# Southwest Light Rail Transit: Kenilworth Shallow LRT Tunnels Water Resources Evaluation

**Metropolitan Council**

**Project No. 76701**

**Revision 0  
January 30, 2013**

**Figure 2: Construction Sheet Pile Cell**

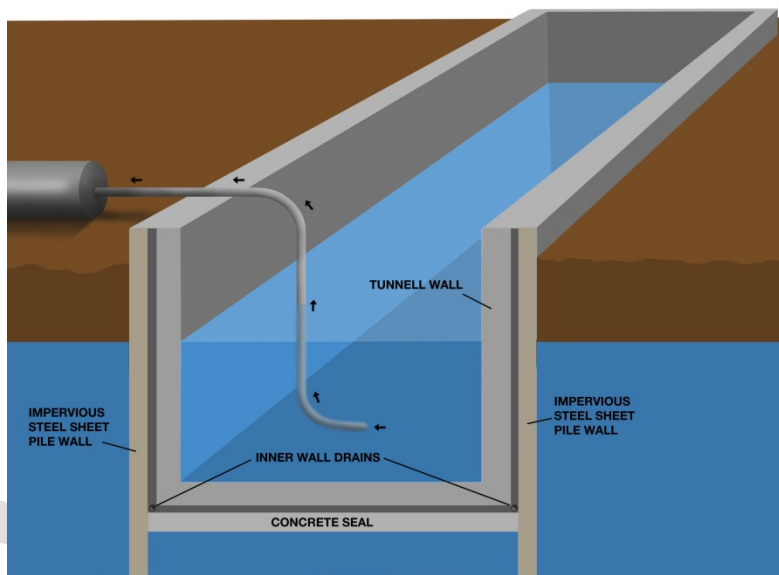
- Based on our understanding of the proposed construction method, the Cell 1 (Excavation) dewatering calculation would not apply because no pumping of groundwater would occur until after the excavation is complete and the concrete seal is in place. At that point the Cell 2 (Construction) scenario would apply.

- Although sealed sheet piling joints are proposed in the BODR, the analysis for groundwater control during construction of the excavation cells appears to assume open joints as stated in the BODR construction sequence.

- The calculation for groundwater removal in the excavation cell factors in the seepage rate for each sheet piling joint, the total number of joints, and the maximum precipitation anticipated to occur during the 15-day construction period. Additionally, this calculation factors in the volume of the cell that is below lake level during the 15-day period. However, when this volume is factored into the calculated pumping rate for the excavation cell a 45-day period is assumed. Groundwater removal from the excavation cell will occur in 15 days as that is the length of time the cell will be under construction. If the 15-day excavation cell period is substituted in place of the 45-day period, the resultant pumping rate is 24.6 gpm, rather than the 10 gpm reported in the BODR.

- For the Cell 2 (Construction) calculation (in which the sheet pile joints will be sealed) a joint resistance of  $1.0 \times 10^{-7}$  m/s is used. A joint resistance of  $3 \times 10^{-10}$  m/s should be used (according to the referenced sheet pile manual). When this factor is applied in the spreadsheet calculation, a pumping rate of 0.6 gpm is the result, rather than 2.4 gpm presented in the BODR.

- The source of the presumed rainfall amounts (6 inches for the excavation scenario and 12 inches for the construction scenario) was not stated. This would be a significant amount of rainfall and, therefore, would likely represent a near-worst case scenario for precipitation. It is recommended that the source of the precipitation amounts used in the calculations be stated.

**Figure 3: Portal Water Control System**

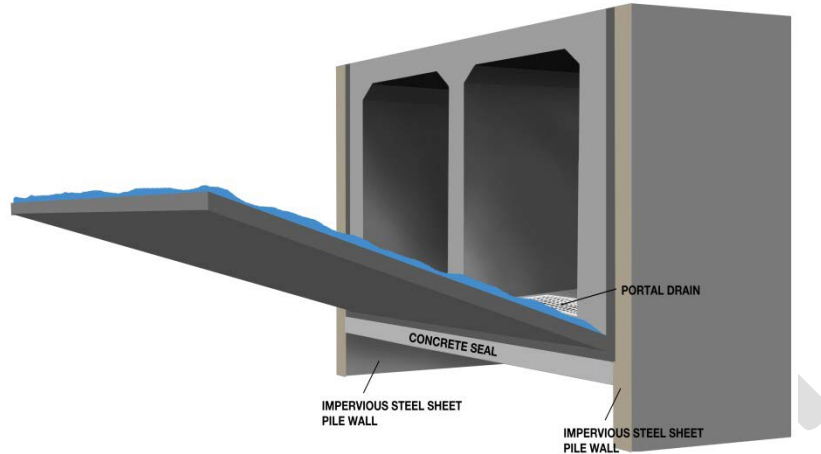
Stormwater volumes provided in the BODR for the 50-year and 100-year design storm events were 0.26 acre-feet and 0.30 acre-feet, respectively for the South Portal. Using appropriate significant figures for this level of design and the relatively insignificant change from one design storm event to the other, the chambers should be designed for the 100-year design storm with an overflow for greater storm events. Also, stormwater runoff from storms greater than the 50-year design storm event for the portal areas would be directed to the City of Minneapolis or MCES storm sewer system. Storm sewer infrastructure is typically designed for storm events much less than the 50-year event. As recommended for sanitary sewer connections; city of Minneapolis approval and a comprehensive capacity analysis and range of scenarios should also be completed for storm sewer connections to adequately understand potential implications.

**Figure 4: Inner Wall Water Control System**

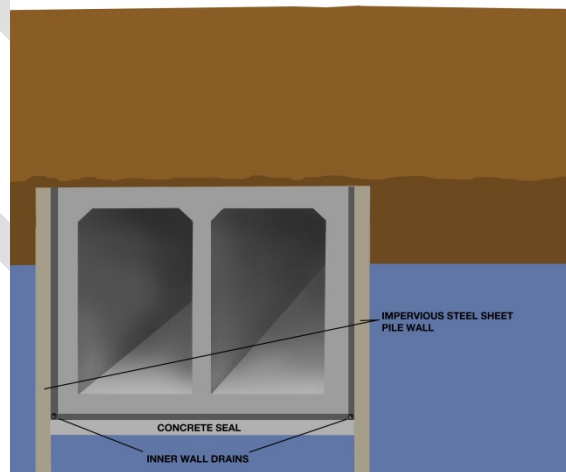
The joint resistance used in the calculation is appropriate for open (unsealed) sheet pile joints (per the referenced sheet pile manual), yet the installation process described in the BODR states that the joints will be sealed. The sheet pile manual suggests using a minimum joint resistance of  $3 \times 10^{-10}$  m/s for sealed joints. If this value is substituted into the spreadsheet equation the infiltration rate is much less than 1 gpm for each tunnel section.

Figure 5: Tunnel Water Control System

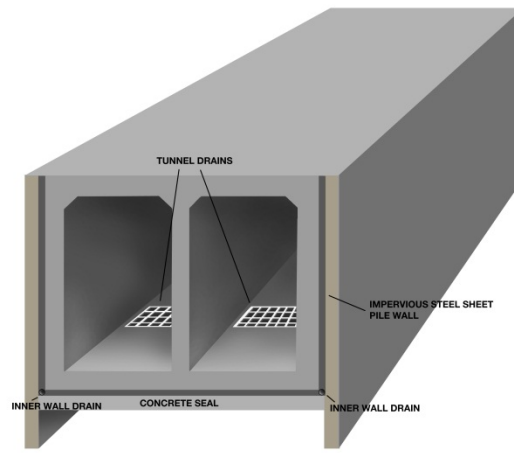
- The calculation for the tunnel surface area appears to be in error. The surface area of each tunnel side and the surface area of the floor slab should be summed to arrive at the total area available for infiltration. This results in a total area of 50,820 square feet. The area calculation in the spreadsheet appears to have multiplied the surface areas of the tunnel sides by the surface area of the floor slab, resulting in total volume of the tunnel segment. Using the permitted infiltration rate of 0.002 gal/sq ft/day, inflows to the tunnel through the tunnel walls and bottom slab are expected to be much lower than presented in the report. For example, the revised calculation indicates an inflow to the south tunnel’s south portal to be more on the order of 0.07 gpm and 37,099 gallons annually, not 2.7 gpm and 1.4 million gallons annually as stated in the BODR. Similarly reduced inflows are indicated for the other portals.

Figure 6: Groundwater Piezometer Data (Vayen, 2013)

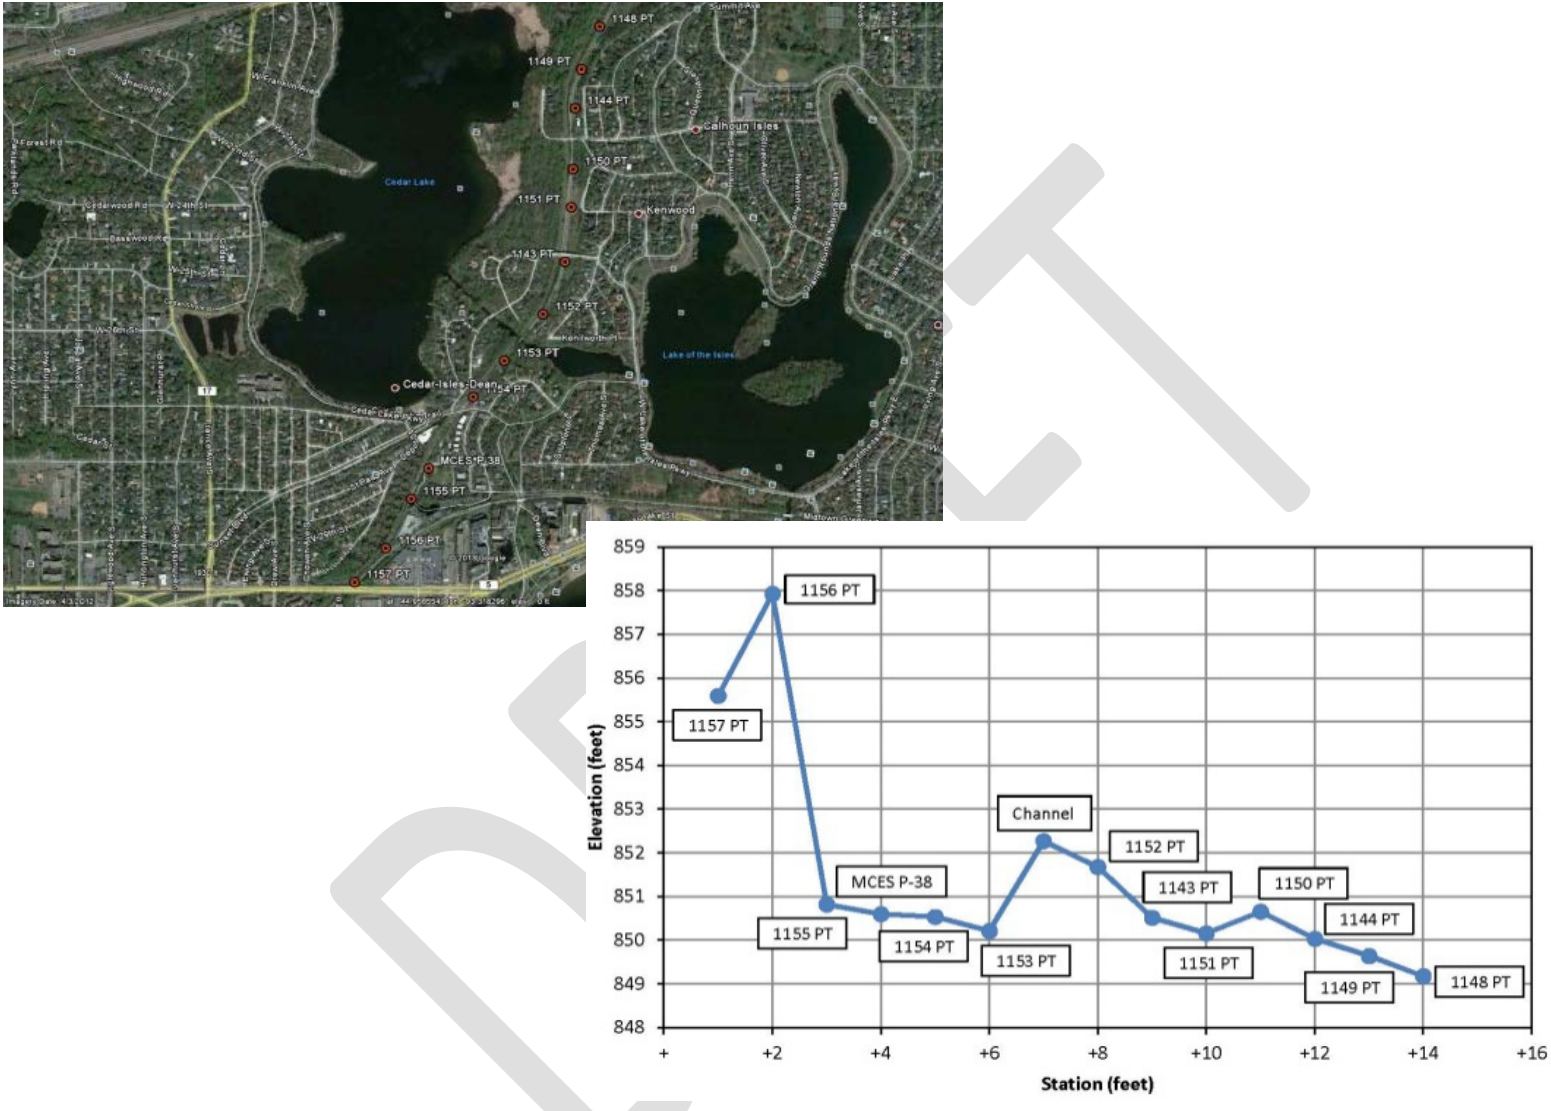
Since the AET piezometers are installed only along the proposed route in the Kenilworth Corridor, they only provide a one dimensional view of the groundwater elevations and it is difficult to conclusively determine the groundwater flow pattern. Additional piezometers lateral to the proposed route are needed to better characterize the groundwater flow system in two dimensions, and a few nested piezometers completed at a greater depth would help to evaluate potential downward flow. Also, the water levels presented are only from October and November 2014. Seasonal water level data are needed to better understand ground water elevations during wet periods and in response to rain events.

- Additional piezometers lateral to the planned route both north and the south of the channel are needed to better characterize the groundwater flow system in two dimensions. Also some sets of nested piezometers should be installed to evaluate vertical groundwater flow in the Kenilworth Corridor. This will help to better characterize and understand the direction and gradient of groundwater flow and the interaction between groundwater and surface water. Also, seasonal water level data are needed to better understand ground water elevations during wet periods and in response to rainfall events.
